## **Access Compliance Report Public Rights-of-Way** (Curb Ramps)

Main Street: CARBON CANYON RD **Cross Street: VALENCIA\_AVE** Location: NE

Severity Score: ADA ID: RPAT210920093043 Ramp Type:Type 1 - Perpendicular **Initial Pass/Fail: Pass Overall Compliance: No**

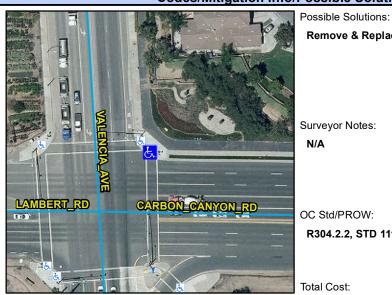
| Field Measurements/Component Compliance |                        |                                  |                               |                        |                               |        |  |  |  |
|---|------------------------|----------------------------------|-------------------------------|------------------------|-------------------------------|--------|--|--|--|
|   | Yes                    | Gutter Ponding                   | No                            | No                     | Curb Slope                    | 8.1    |  |  |  |

Remove & Replace Curb Slope. Utility Present.

R304.2.2, STD 1115
